Project
GORTON COMMUNITY HUB

Drawing Title
Level 2 - Second Floor

Job Number	Date	Drawn By
50786	15/11/18	JW
Scale@A0	Purpose	Reviewed By
1 : 100	CONSTRUCTION ISSUE	TK
Drawing Number	Revision	Suitability
GCH-IBI-XX-02-DR-A-200-0003	C01	S4

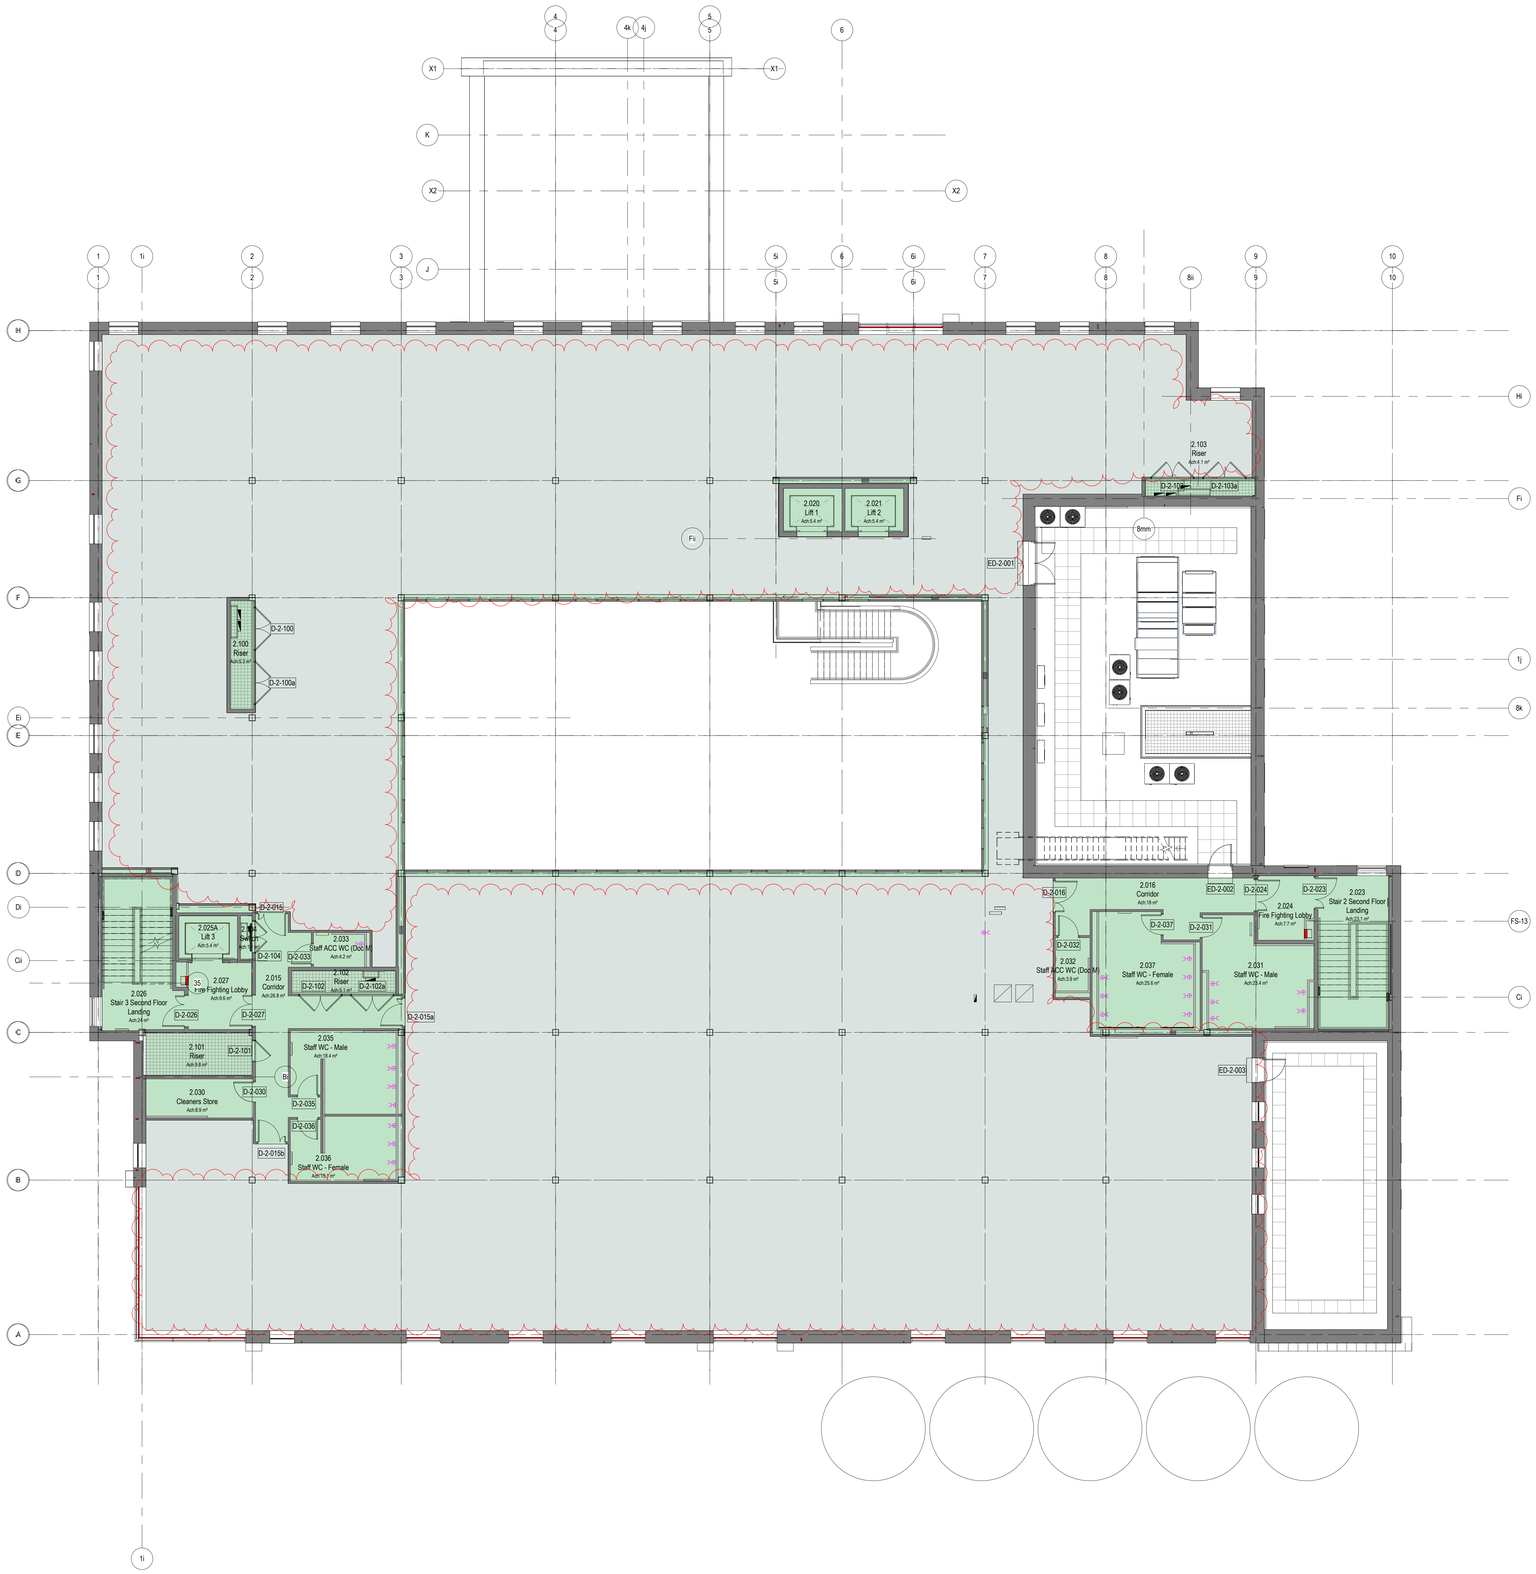
Second Floor - reduced scope key

Internal area to be shell only

- Screed omitted, all floor preparation omitted & exposed concrete slab only
- Floor finishes – carpet, vinyl, ply & accessories omitted
- Wall finishes – painting & tiling omitted
- Suspended ceilings, MF ceilings & shadow battens omitted
- Joinery omitted
- Decorations omitted
- Internal partitions & screens omitted
- Internal doors, ironmongery & frames omitted
- Skirtings omitted
- Window boards omitted
- Patressing omitted

- M&E scope reduced tbc by others

- Fire Strategy changes tbc by others

Note fire proofing to structural steelwork retained - intumescent paint, encasement or combination to be agreed at next stage

Internal area to be retained & fitted out

- Stairs, handrails & balustrading retained
- Stairs nosings retained
- Lifts retained
- Protected corridors retained
- Service risers & service riser doors retained
- Toilet accommodation, cubicles, sanitary & drainage retained
- Screed retained
- Floor finishes – carpet, vinyl, ply & accessories retained
- Wall finishes – painting & tiling retained
- Suspended ceilings, MF ceilings & shadow battens retained
- Joinery retained
- Decorations retained
- Internal partitions & screens retained
- Internal doors, ironmongery & frames retained
- Skirtings retained
- Window boards retained
- Patressing retained
- Internal glazed screens overlooking atrium retained

- M&E scope retained tbc by others

- Fire Strategy changes tbc by others

All external fabric to be retained including external roof, walls, cladding, windows, curtain walling, doors, external stairs
